ATTACHMENT B

3.1.4 Maximum Coolant Activity

ATTACHMENT C

Revise the Technical Specification pages as follows:

FIGURE 3.1.4-1

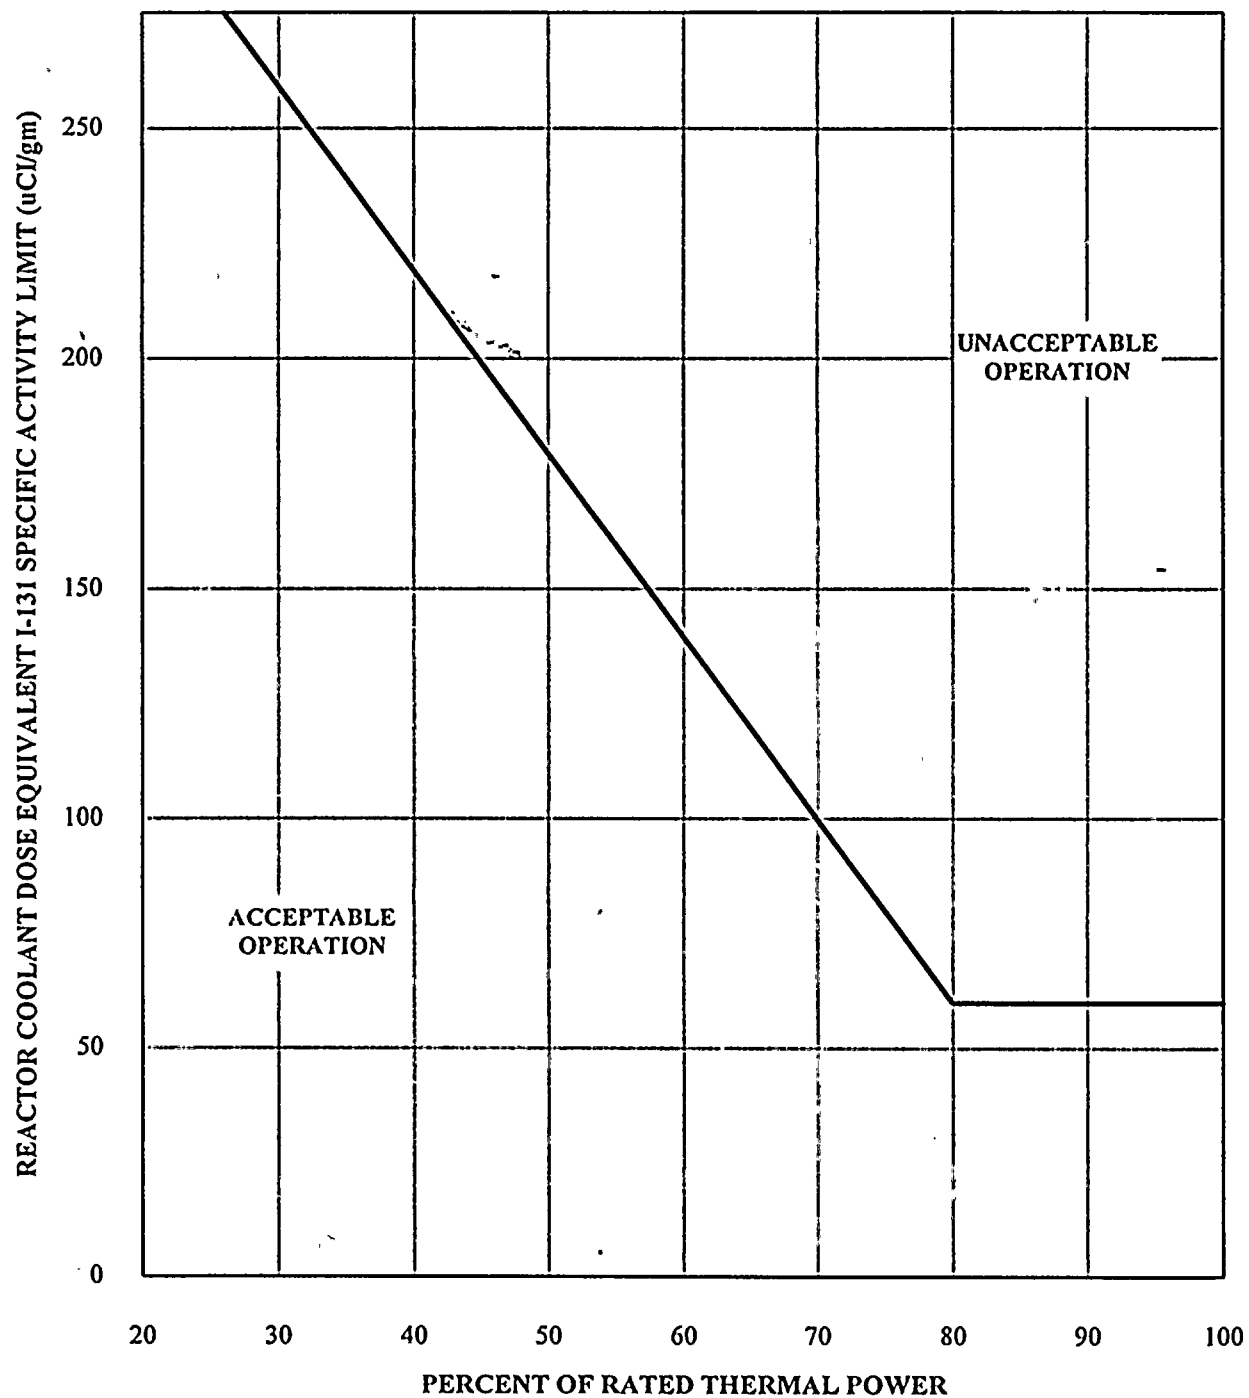
3.1.4.3 a. If the I-131 equivalent activity in the reactor coolant exceeds the limit of 3.1.4.1.b but is less than the allowable limit shown on Figure 3.1.4-1, operation may continue for up to 168 hours. ~~If the I-131 equivalent activity in the reactor coolant exceeds the limit of 3.1.4.1.b for more than 500 hours in any consecutive 6 month period, then prepare and submit a report to the Commission pursuant to Specification 6.9.2.~~

- 3.1.4.1 Whenever the reactor is critical or the reactor coolant average temperature is greater than 500°F:
- a. The total specific activity of the reactor coolant shall not exceed $100/\bar{E}$ $\mu\text{Ci/gm}$, where \bar{E} is the average beta and gamma energies per disintegration in Mev.
 - b. The I-131 dose equivalent of the iodine activity in the reactor coolant shall not exceed 1.0 $\mu\text{Ci/gm}$.
 - c. The I-131 equivalent of the iodine activity on the secondary side of a steam generator shall not exceed 0.1 $\mu\text{Ci/gm}$.
- 3.1.4.2 If the limit of 3.1.4.1.a is exceeded, then be subcritical with reactor coolant average temperature less than 500°F within 8 hours.
- 3.1.4.3 a. If the I-131 equivalent activity in the reactor coolant exceeds the limit of 3.1.4.1.b but is less than the allowable limit shown on Figure 3.1.4-1, operation may continue for up to 168 hours.
